2018 Mercedes Benz E63S AMG 4MATIC Sed (213.089) V8-4.0L Turbo (177.980)

NOISES FROM DYNAMIC SEAT

Topic number	LI91.25-P-071314
Version	1
Function group	91.25 Multicontour seat (MKS)
Date	06-16-2020
Validity	MODEL 213 with code 432 (Active Multicontour Seat Package) MODEL 257 with code 432 (Active Multicontour Seat Package) MODEL 290 with code 432 (Active Multicontour Seat Package)
Reason for change

Bearbeitung Spannband 1

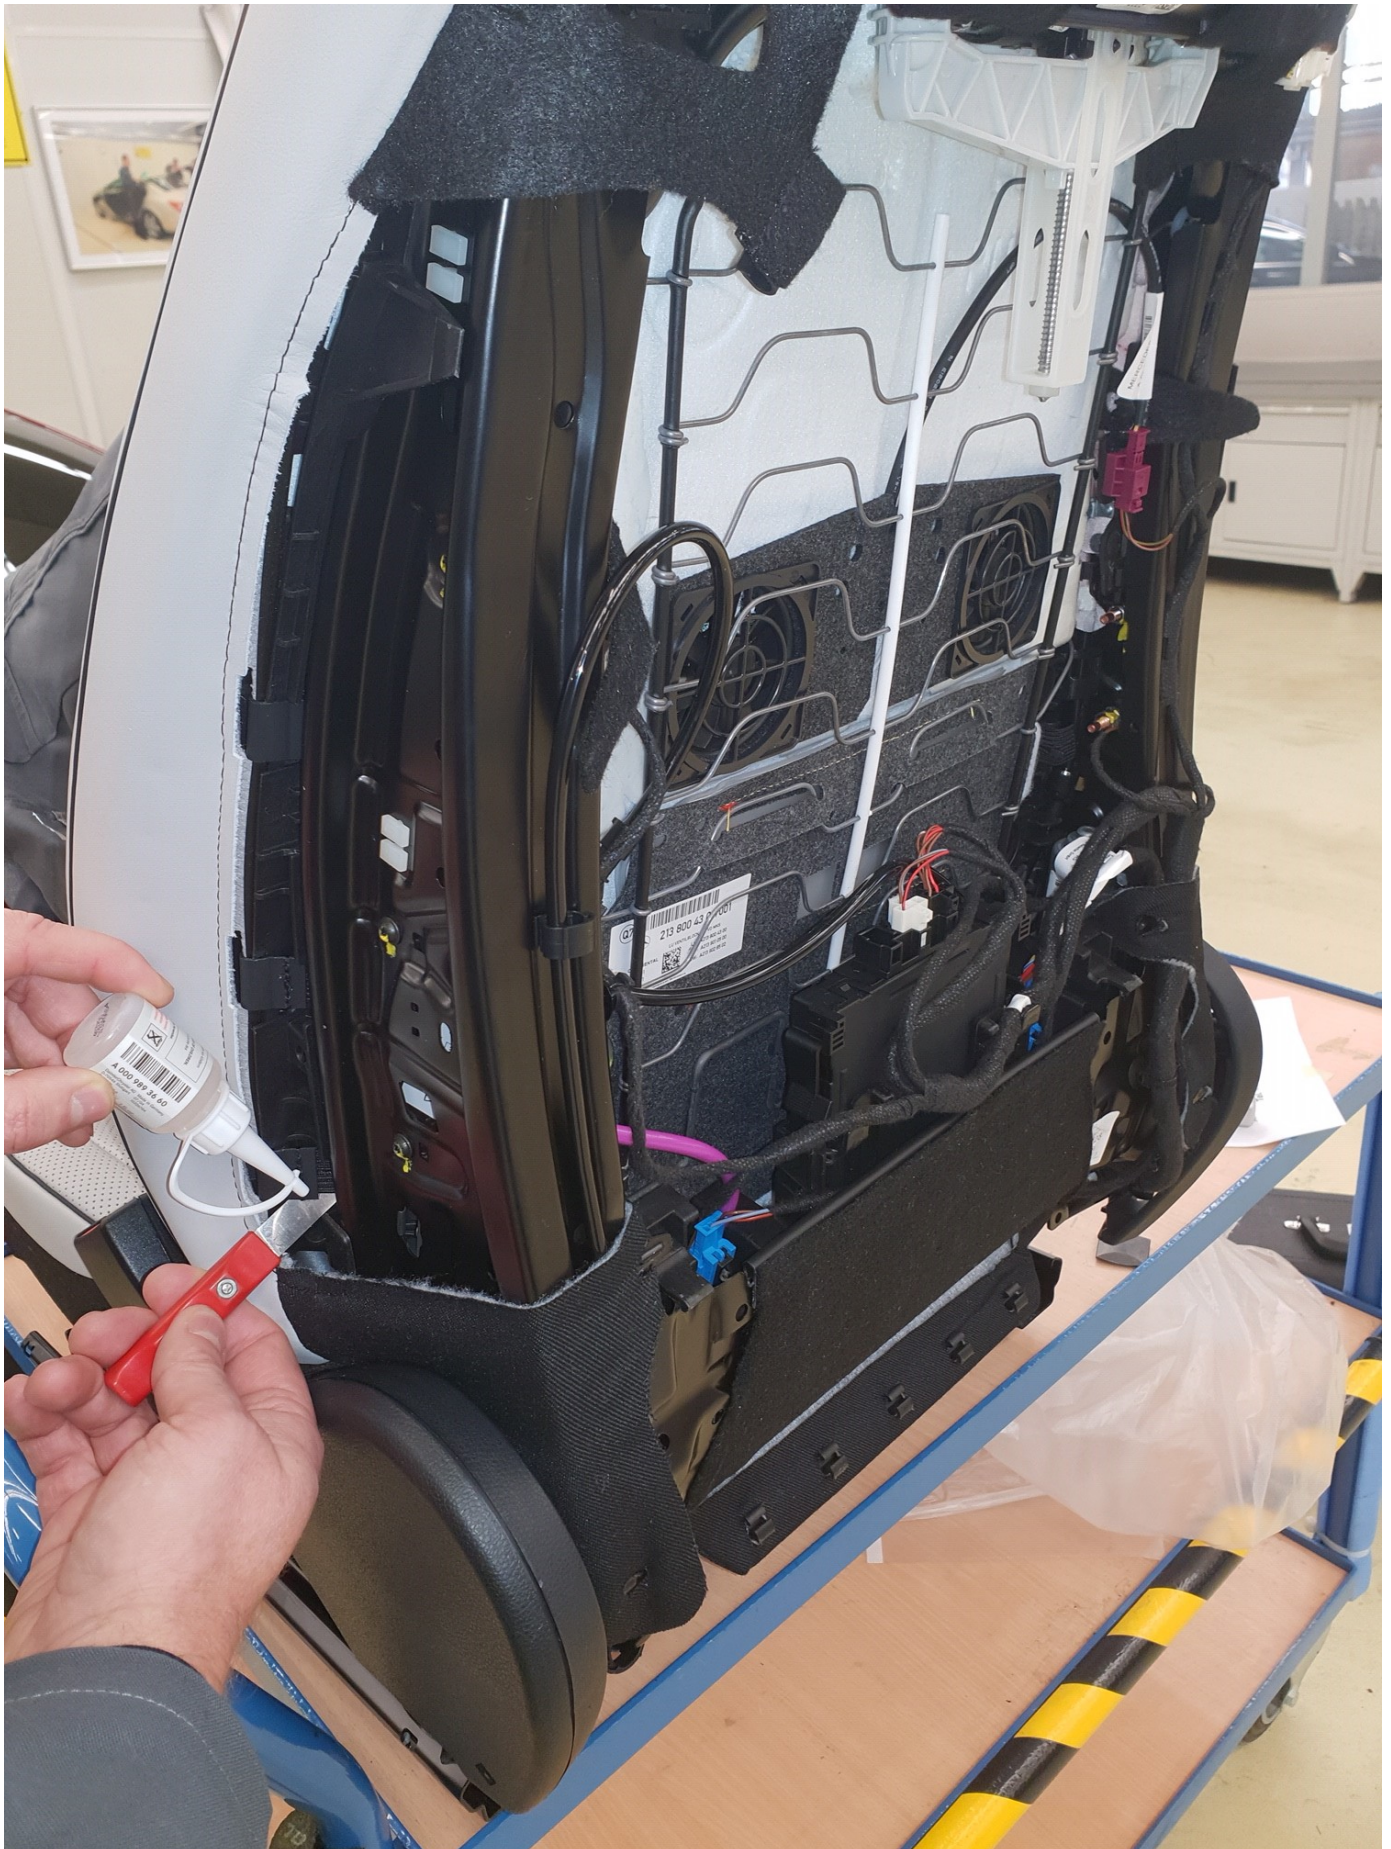
When the dynamic seat is activated, the tensioning straps on the seat backrest frame may creak.

The tensioning straps are in contact with the seat backrest frame and as a result, a creaking noise may occur.

Apply lubricant (Krytox) between the tensioning strap and the seat backrest frame, see figures.
